Lilac Hills Ranch

Traffic Impact Study

**Roundabout Peer Review
Exhibit of Findings
October 2013**

Project Title:	W Lilac Rd Roundabouts	Design Phase (%):	Conceptual
Owner:	Accretive Investments, Inc.	Date:	October 25, 2013

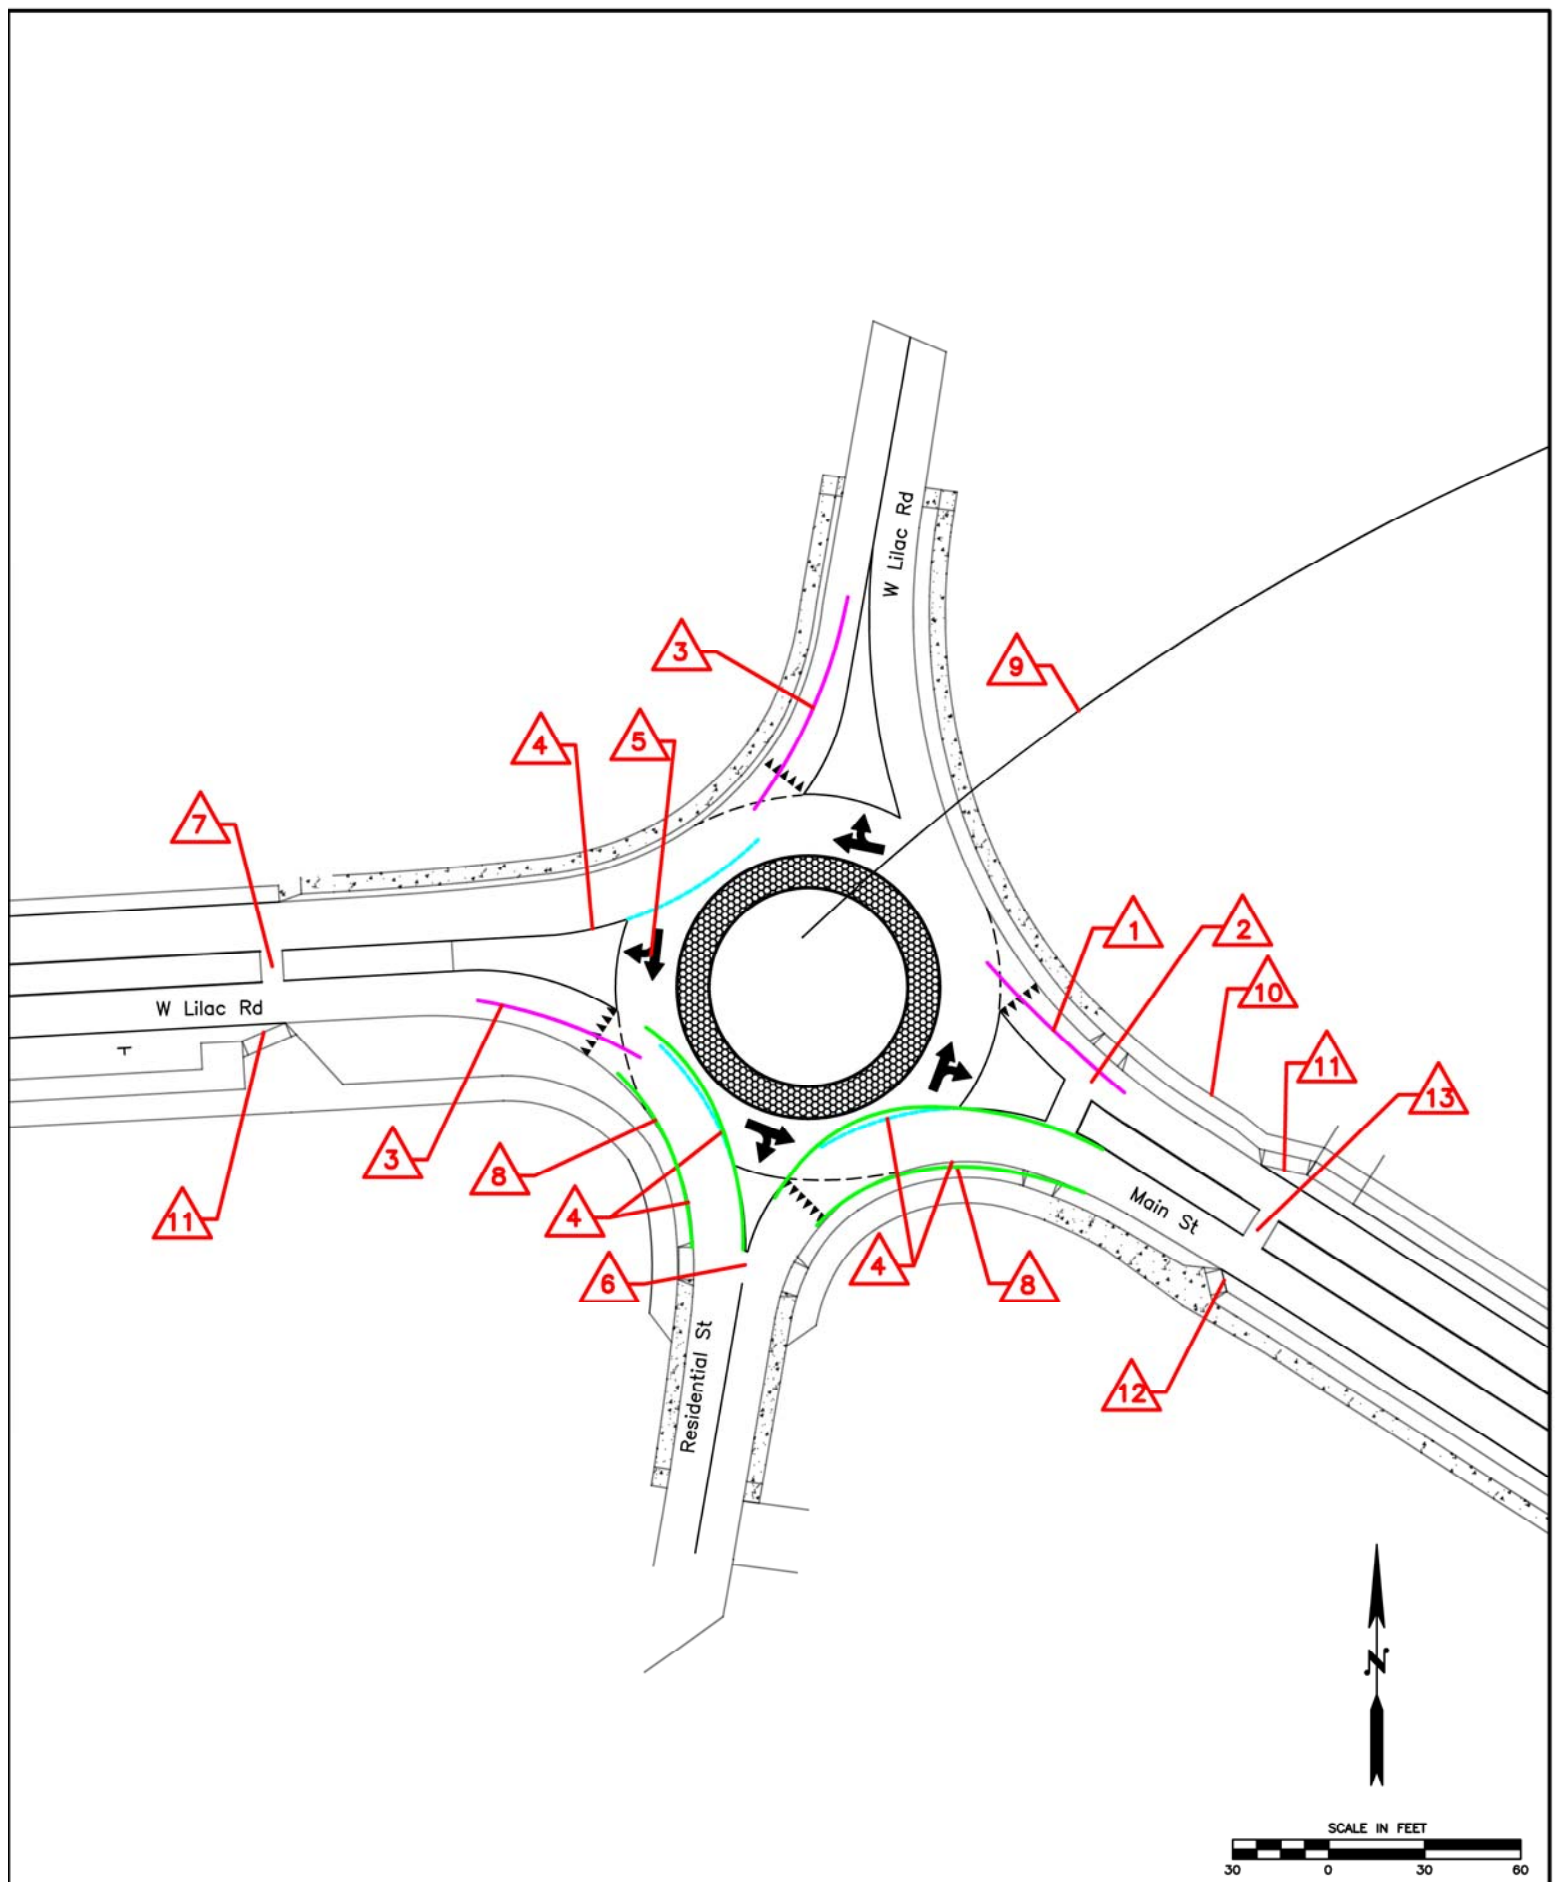
Peer Review RB 1	A four-leg conceptual roundabout with the existing W Lilac Rd configuration was reviewed. The following item nos. 1-13 correspond to the triangular callouts on Figure 1.

Topic/ Reference	Comment
Item 1 (Figure 1)	The geometry for the approach from Main St does not slow vehicles as they enter the roundabout. Vehicles can enter the roundabout at a speed greater than 40mph while the conflicting traffic would be traveling approximately 15mph. Speeds this fast negate the innate safety benefits associated with single lane roundabouts. There will be an increase in failure to yield, increasing the potential for collisions. In addition, these potential collisions will result in severe damage due to the high speed differentials. A speed differential 6-7mph in conflicting paths is recommended at this location. In addition, entering speeds should be approximately 20-22mph.

Item 2 (Figure 1)	The geometry for the approach from Main St does nothing to slow vehicles down prior to the crosswalk location. The safety of pedestrian, bicycles, and equestrian users are dependent on slow vehicle speeds, controlled by the geometry of the roundabout. In addition, the commuter bicyclists will want to merge with vehicle traffic to negotiate the roundabout which is easier and safer when speeds are kept around 20-22mph.

Item 3 (Figure 1)	The geometry for the approaches from W Lilac Rd (both the west and north leg) do not slow vehicles sufficiently. Vehicles can enter the roundabout at 25mph while an entering speed of 20-22mph is more appropriate for a roundabout. See Item 2.

Item 4 (Figure 1)	The exit onto Main St, Residential St and W Lilac Rd (west leg) is not a natural path. Vehicles will need to brake to negotiate the exit safely, contrary to driver expectation. In addition, the splitter island does not guide circulating vehicles out of the roundabout in a path that is natural (see cyan line). The radius of this splitter island stripe should be tangent with the central truck apron curb. The potential for curb strikes on these exits is high and the capacity will be decreased with this type of design.

Item 5 (Figure 1)	Pavement marking arrows in circulating lane for a single lane roundabout are not recommended.
Item 6 (Figure 1)	The splitter island is too short on the Residential St. A minimum splitter island length of 50ft is recommended for this location. In addition, the pedestrian refuge is compromised on this leg. The pedestrian refuge island is an important safety feature at this location due to the trail connection and pedestrian connectivity.

Item 7 (Figure 1)	The bicycle crossing on W Lilac Rd (west leg) is located too far from the roundabout to get any safety benefits associated with vehicles slowing to negotiate the intersection. Ideally these crossings should be located one car length from the circulating roadway of the roundabout.

Item 8 (Figure 1)	The design vehicle (WB-50) does not seem to be accommodated on the exit to the Residential St and to Main St (see green lines depicting the tire tracks). A design vehicle should be able to negotiate the roundabout without having to put the tractor tires onto the truck apron (which is reserved for the trailer part of the truck). It is recommended that a WB-50 be able to negotiate this roundabout to ensure construction vehicles for the development will have adequate access.

Topic/ Reference	Comment
Item 9 (Figure 1)	It is not clear how this roundabout would accommodate the proposed IOD without major shifts in central island location or other approach alignments.

Item 10 (Figure 1)	The minimum recommended multiuse trail is 8ft. On Main St from the bike ramp to the pedestrian crosswalk, a minimum width of 8ft should be maintained.

Item 11 (Figure 1)	The bike ramp to the multiuse trail from W Lilac Rd and Main St is too wide. This may be mistaken as a driveway and entice vehicle traffic. In addition, RM does not recommend bicycle ramps oriented this way as less experienced bicyclists will swerve into travel lane to line themselves up with the ramp. See Appendix E for more explanation on Bicycle Treatment Facilities.

Item 12 (Figure 1)	The bicycle ramp exiting onto Main St is angled in a way that inexperienced bicyclists will be guided into the vehicle traffic. See Appendix E for more explanation on Bicycle Facilities.

Item 13 (Figure 1)	This location is not recommended as a bicycle crossing (see Item 7).
Peer Review RB 2	The conceptual layout of RB 2 was in the development stages of design. Therefore, the roundabout details were not reviewed, including the design of bicycle and pedestrian facilities. The following item nos. 14-21 correspond to the triangular callouts on Figure 2.

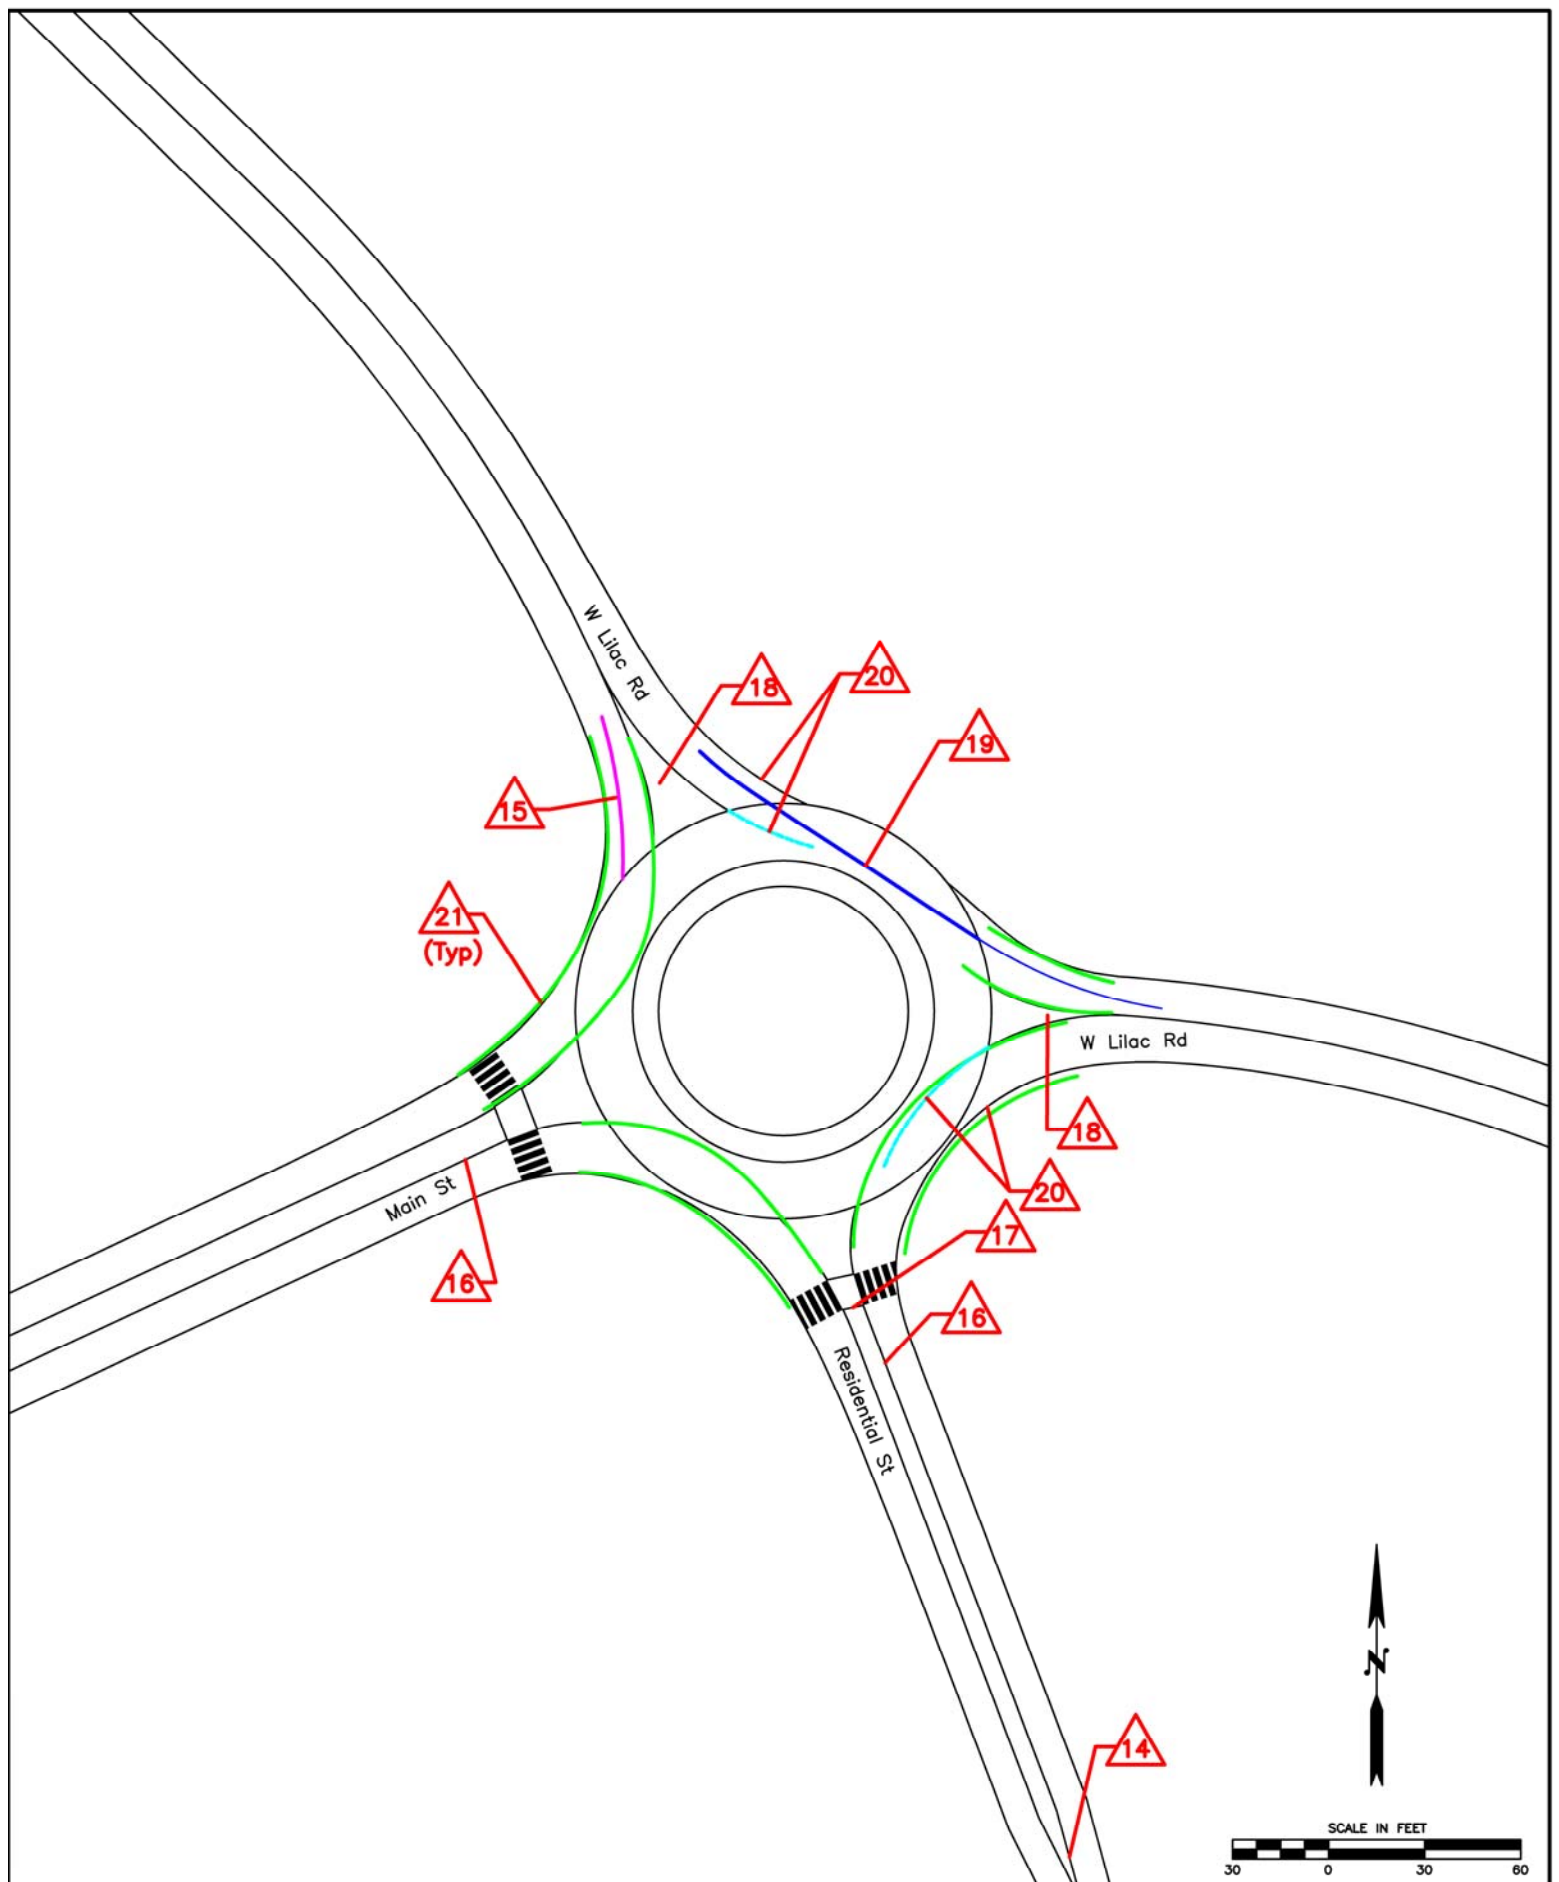
Item 14 (Figure 2)	The taper rate for the splitter island on the Residential St is abrupt for an approach speed of 30mph.
Item 15 (Figure 2)	The geometry for the approach from W Lilac Rd (north leg) does not slow vehicles sufficiently as they enter the roundabout. Vehicles can enter the roundabout at 25mph while an entering speed of 20-22mph is more appropriate for a roundabout. This will ensure the safety benefits and capacity predicted for this single lane roundabout are achieved.

Item 16 (Figure 2)	The geometry for the approach from Main St and the Residential St does nothing to slow vehicles down prior to the crosswalk location, which causes safety concerns.

Topic/ Reference	Comment
Item 17 (Figure 2)	The pedestrian refuge island on the Residential St may not meet current standards for a minimum distance of 6.0ft. This refuge does not provide adequate protection.

Item 18 (Figure 2)	The splitter islands are too short on W Lilac Rd (both the north and east legs). A minimum splitter island length is 50ft, however due to the higher speeds on this approach a longer splitter island is desirable (100-150ft).

Item 19 (Figure 2)	The right turn from westbound W Lilac Rd is an unnatural path. Drivers will straighten this path out (see difference between outside curb lines and the blue line). The straightened path creates a faster right turn that is appropriate at this location. In addition, the unused space is inefficient and will collect debris.

Item 20 (Figure 2)	All of the exits from this roundabout are designed with an unnatural path, however, it is more pronounced on the W Lilac Rd (north and east legs). Vehicles will need to brake to negotiate these exits safely, contrary to driver expectation. In addition, the splitter island does not guide circulating vehicles out of the roundabout in a path that is natural (see cyan line). The radius of this splitter island stripe should be tangent with the central truck apron curb. The potential for curb strikes on these exits is high and the capacity will be decreased with this type of design.

Item 21 (Figure 2)	The design vehicle (WB-50) does not seem to be accommodated on the exit to the Residential St and to Main St (see green lines depicting the tire tracks). A design vehicle should be able to negotiate the roundabout without having to put the tractor tires onto the truck apron (which is reserved for the trailer part of the truck). It is recommended that a WB-50 be able to negotiate this roundabout to ensure construction vehicles for the development will have adequate access.
RM Design RB 1 RB 1 (Alt A) RB 1 (Alt B)	RM designed a conceptual roundabout that addresses the above concerns of the first intersection. This layout, RB 1, is designed to accommodate the existing W Lilac Rd (north leg). The following item nos. 22-25 correspond to the circular callouts on Figure 3. The roundabout is versatile so that with minor modifications, it will accommodate the proposed IOD alignment rather than the existing W Lilac Rd (north leg). The location of the central island and three legs are the same in this roundabout, RB 1 (Alt A) as in RB 1. An accurate representation of the roundabout impacts, regardless of which alignment is built for that fourth leg, can be determined and quantified for the majority of the intersection. Item no. 26 corresponds to the circular callouts on Figure 4. Finally, in an effort to provide for both the W Lilac Rd (north leg) and proposed IOD alignment, a five-leg roundabout, RB 1 (Alt B) was designed. The following item nos. 27-29 correspond to the circular callouts on Figure 5. Appendix B contains all the corresponding back-up calculations for the horizontal geometrics of these RM conceptual roundabouts such as fastest paths, truck turning movements and sight distance requirements.
